Technical Service Bulletin (TSB)
Flash: Motor Control Processor B (MCP B) Updates 6A1

REFERENCE:	TSB: 08-024-25 REV. B GROUP: 08 - Electrical	Date:	April 29, 2025	REVISION:	08-024-25 REV. A
VEHICLES AFFECTED:	2025 (LB) Dodge Charger This bulletin applies to vehicles built on and before **April 03, 2025 (MDH 0403XX)** equipped with 400V G2500 FR/RR Elec Drive Motors (Sales Code ELD).	MARKET APPLICABILITY:		<input checked="" type="checkbox"/> NA	<input checked="" type="checkbox"/> MEA
				<input checked="" type="checkbox"/> SA	<input checked="" type="checkbox"/> IAP
				<input checked="" type="checkbox"/> EE	<input checked="" type="checkbox"/> CH
CUSTOMER SYMPTOM:	<p>Customers must experience a Malfunction Indicator Lamp (MIL) illumination and the vehicle must exhibit/set the following Diagnostic Trouble Code (DTC):</p> <ul style="list-style-type: none"> ● P1626-00 - Park Pawl Motor Stuck. <p>The customer may comment on one or more of the following symptoms:</p> <ul style="list-style-type: none"> ● Wrench icon is illuminated on the Instrument Panel Cluster (IPC). ● Turtle icon illuminated on the IPC. ● Reduced power. ● Vehicle will not shift out of park.

This bulletin supersedes Te

Fig. 3
#38 AGSM Fuse Location

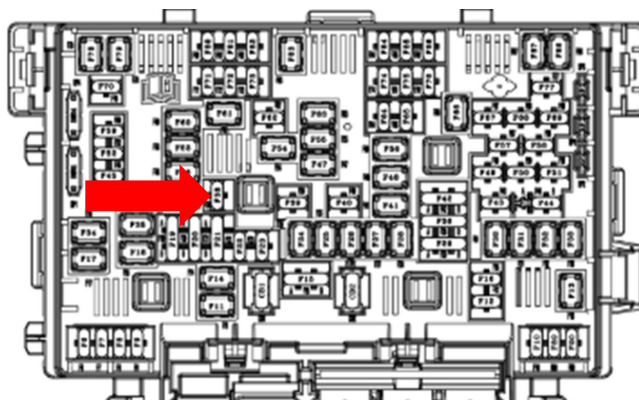
6. Remove the PDC cover, locate and remove the #38 AGSM fuse [Fig. 3](#).**

24. **Install the #38 AGSM fuse [Fig. 3](#) and the PDC cover [Fig. 2](#).
25. Position the rear carpet in place.**
26. Connect the cooling fan wire harness connector [Fig. 1](#).
27. Install the front storage bin. Refer to the detailed service procedures available in DealerCONNECT/ ServiceLibrary under: Service Info> 23 - Body / Exterior / Bin, Storage / Installation.
28. Clear any DTCs that may have been set in any modules due to reprogramming. The wiTECH application will automatically present all DTCs after the flash and allow them to be cleared.
